## SERVICE BULLETIN

Classification:	Reference:	Date:
BT17-007a	NTB17-056a	January 8, 2018

### 2016-2018 TITAN AND TITAN XD; DOOR WILL NOT OPEN OR DOOR WILL NOT LATCH

This bulletin has been amended. The **APPLIED VEHICLES** have been updated and the **SERVICE PROCEDURE** now includes the addition of foam to the outside handle bracket. Please discard previous versions of this bulletin.

Figure 1

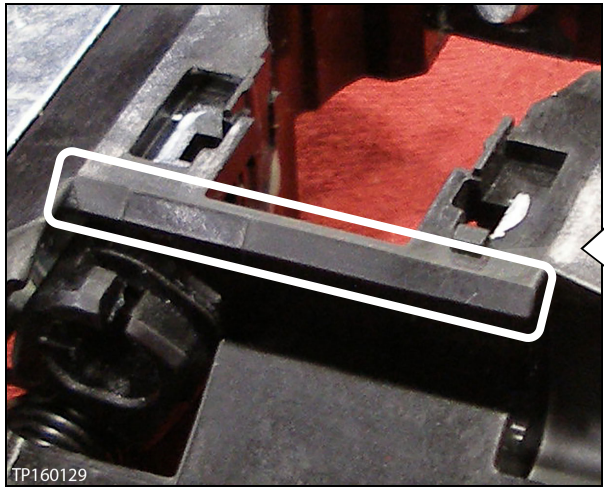
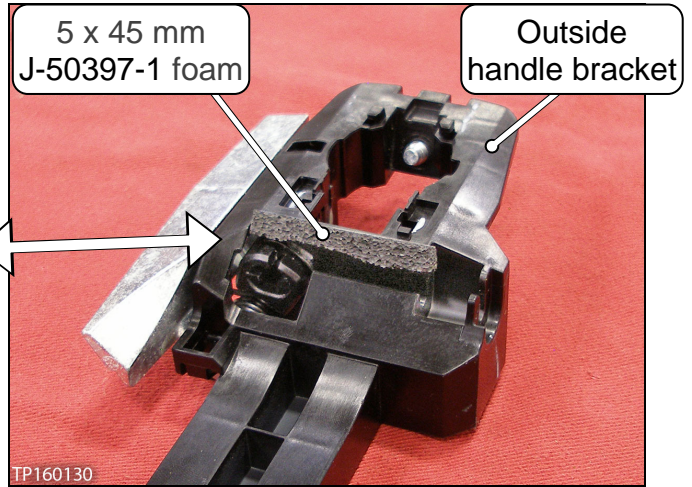
3. Apply both pieces of foam:
  - a. Make sure the areas where the new foam is being applied are clean and dry.
  - b. Apply the vertical piece on the angled surface as shown in Figures 1 and 2.

2. For each outside handle bracket: Cut two (2) pieces of foam:
  - Use only EPDM Semi Closed Cell (J-50397-1) type foam (see **PARTS INFORMATION**).
  - Foam dimensions (both pieces): 5 x 45 mm (see Figures 2 and 3).

Figure 3

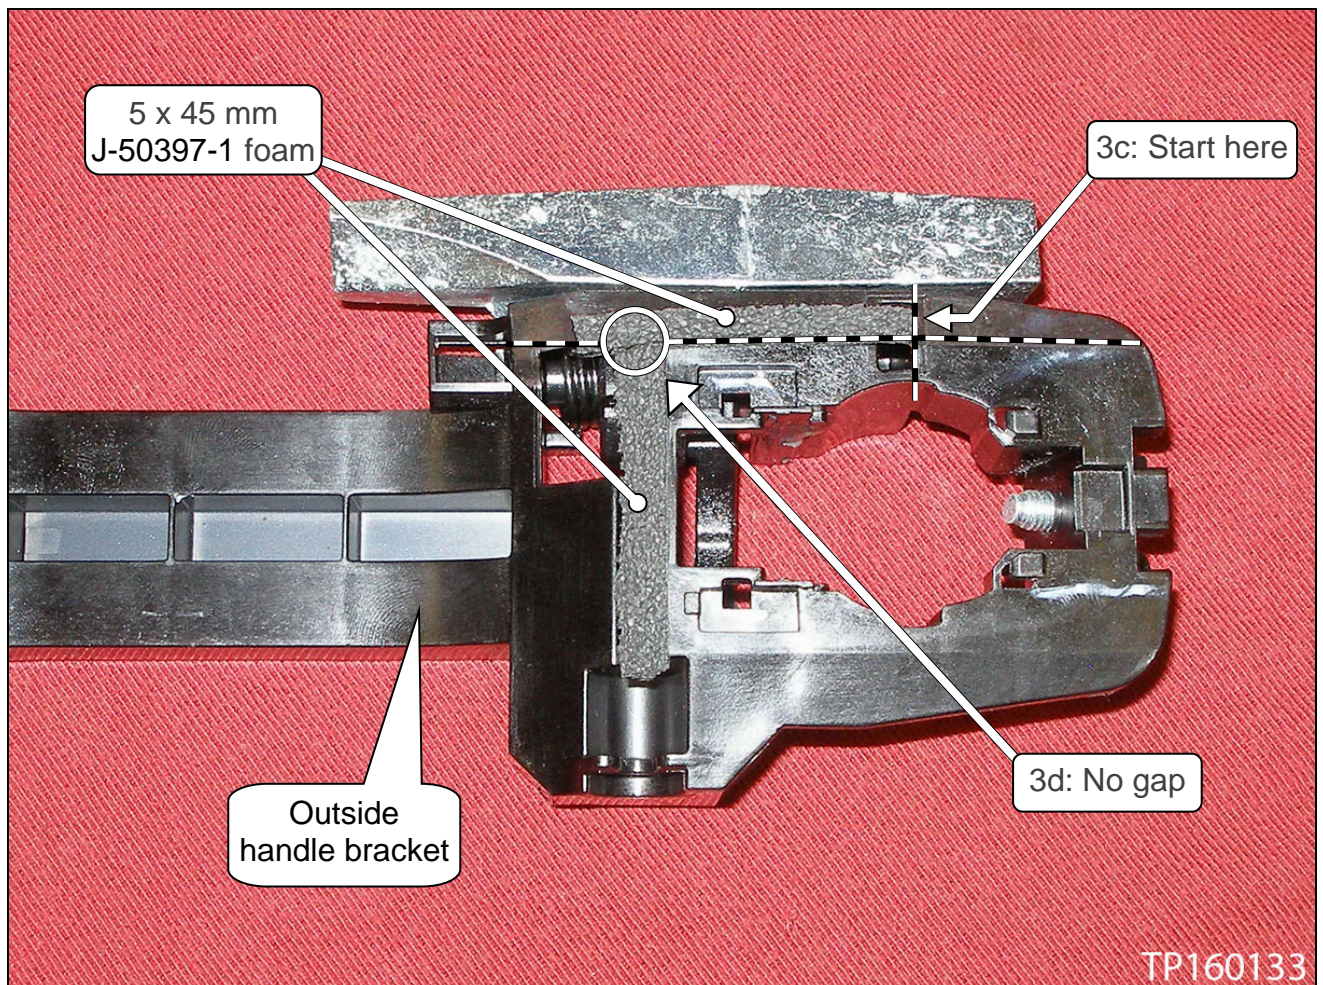
- c. Make sure the horizontal piece starts where shown in Figure 3.
  - d. Apply the horizontal piece making sure there is no gap between both pieces of foam (see Figure 3).

Front door lock

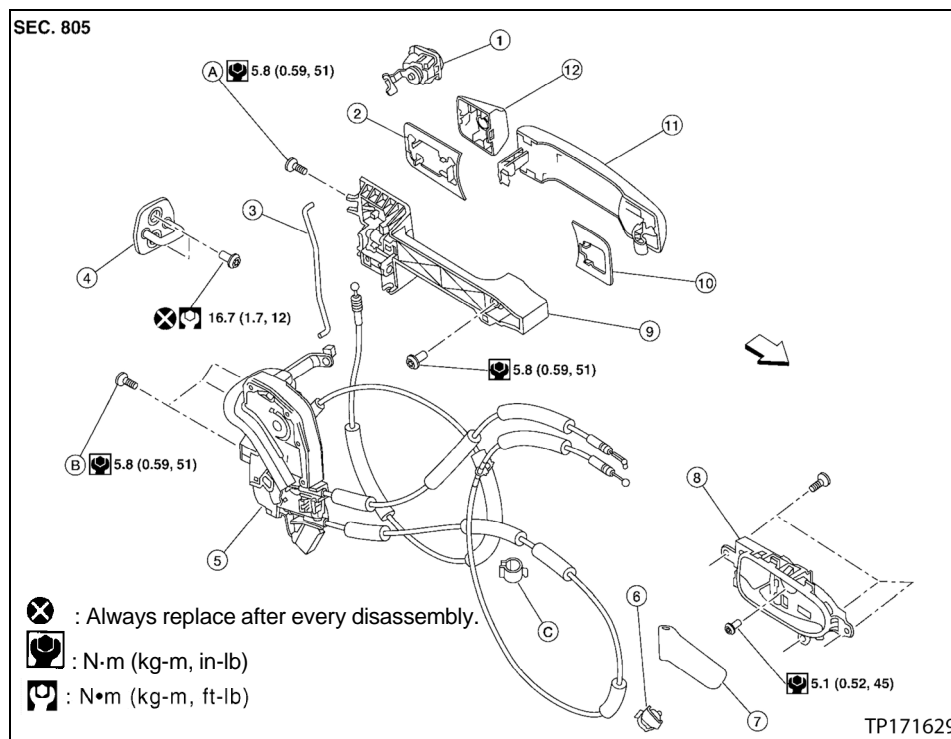
4. Install / reinstall all door lock parts.

**NOTE:** The screws that fasten the door locks are one-time use and will also need to be replaced (see **PARTS INFORMATION**).
